An Independent Assessment of the **Hillside Copper Mine**
Proposal (Mining Lease Proposal & Management Plan) by Rex
Minerals Ltd with a Focus on Marine Impacts

Associate Professor Jochen Kaempf

Figure 1: Proposed Hillside Project Location. The red-bounded area indicates the EML (Extractive Mineral Lease) boundary. Taken from the proponent’s proposal.

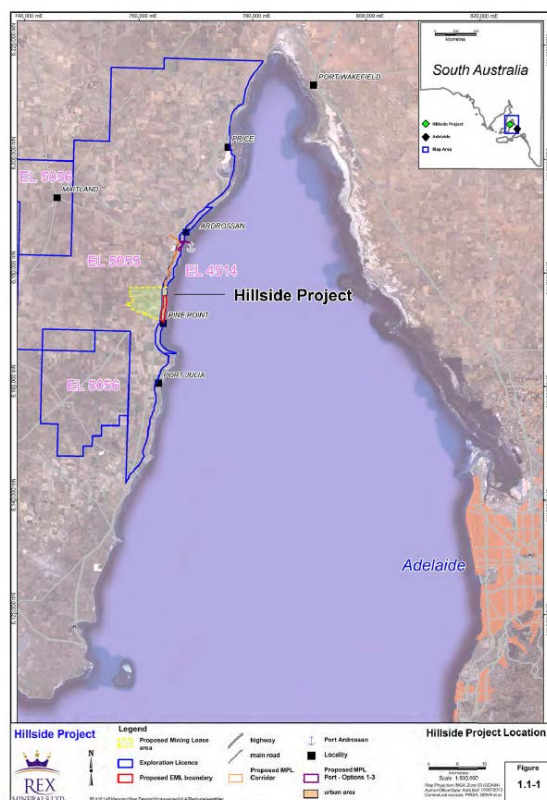
Rex Minerals Ltd (henceforth referred to as “proponent”) propose to build South Australia’s second largest open-pit mine for the production of 335 Kt/annum of copper/gold concentrate and 1.2 Mt/annum of magnetite concentrate for a period exceeding 15 years. This large mine is proposed to be located in the upper Gulf St. Vincent, near Pine Point at a distance of ~8 km from Ardrossan. The proposed lease site stretches over a distance of 3 km along the coastline and the open pit mine will be located close – within kilometres – from the sea (**Figure 1**).

Figure 4: Predicted maximum 24-hour PM₁₀ concentration – including background concentrations with dust emission controls in place. Figure 8.3-2 of the proponent’s proposal.

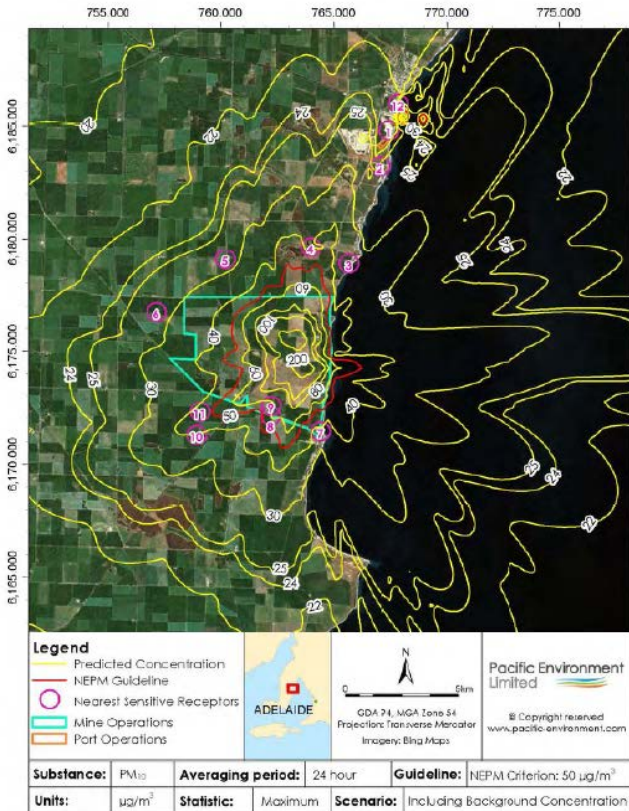
The proponent has neither reviewed nor scientifically explored the physical oceanography of Gulf St. Vincent and its upper reaches. The proponent has decided not to simulate the pathway and dispersal of coastal surface runoff events and the sediment contained in it. The proponent has also decided not to scientifically study the pathway and dispersal of mining-related dust deposition in the marine environment. Consequently, the proponent’s claims in the impact assessment that both factors (ML-A7, ML-SW1,2,3,4) are of minor consequences cannot be scientifically tested and are pure speculations being void of any credible scientific evidence. Hence, the assessment of marine-related consequences presented as part of the proposal does not meet the required scientific standards and should be rejected. Indeed, due to the close vicinity of mining activities, the marine environment must be declared one of the “nearest sensitive receptors”. Figure 8.3-2 of the proposal (reproduced here as **Figure 4**) demonstrates the proponent’s ignorance of the marine environment.
